**US Army Corps
of Engineers**
Chicago District

1985 Annual Report on Lake Michigan Diversion

**(Including State of Illinois Water Year 1983
Accounting Report)**

MONITORING OF DIVERSION
OF LAKE MICHIGAN WATER
AT CHICAGO, ILLINOIS

Figure 2

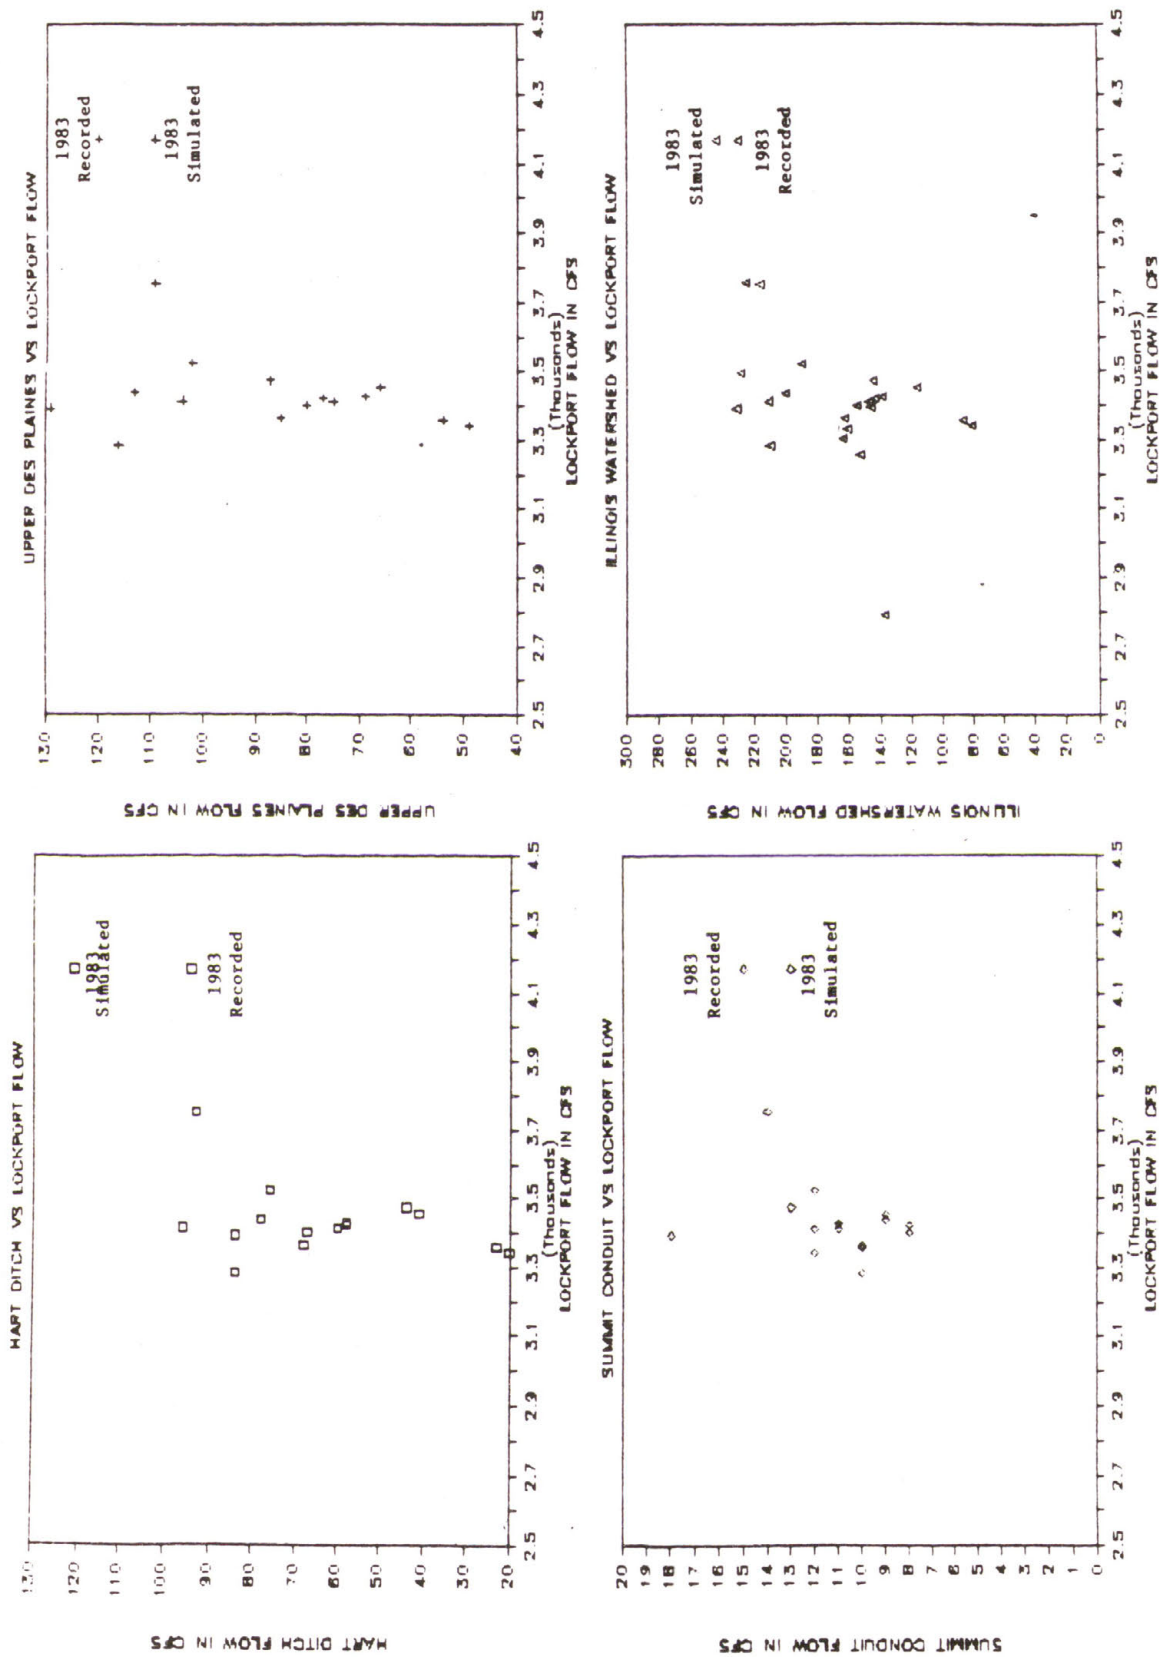
Historical flows at Lockport were plotted against historical runoff component flows (Figure 2). The plots did not result in a linear correlation between total flow at Lockport and runoff component flows. Instead, the plots showed a scattering of data points. The 1983 values for runoff components are reasonable when compared to the range of historic values, as shown in the table below.

Figure 1

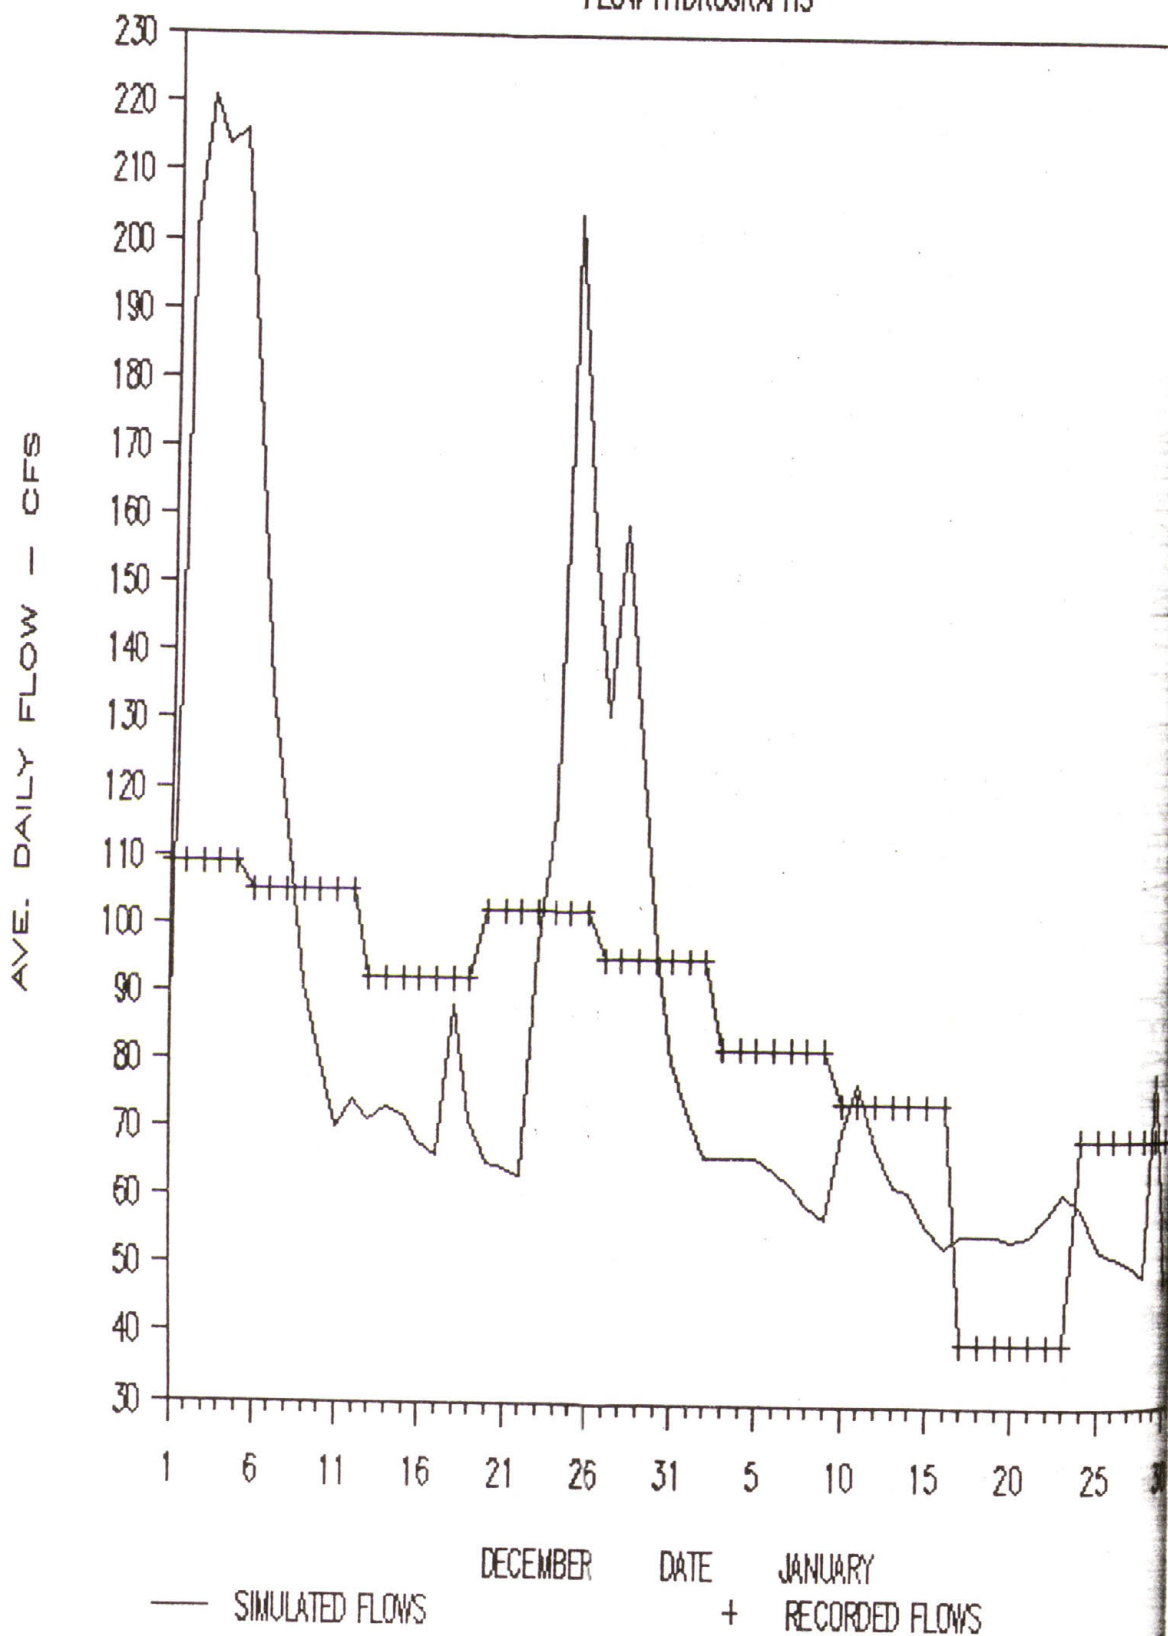
The Corps found that the simulated flows failed to match the recorded flows at the UDPPS (figure 7), but did match the flows at the West-Southwest Treatment Plant at Stickney (figure 8). A field inspection by the Corps verified that, during high flow periods, flows were capable of bypassing the UDPPS metering system. Conversely, during low or normal flows, effluent being pumped could leak back into the sump, resulting in double counting and high metered flows. During the 1983 water year, the new system reported 109 cfs of which 77 cfs flowed through the UDPPS. Direct measurements at the UDPPS were 85 cfs, or 10% higher than simulated.
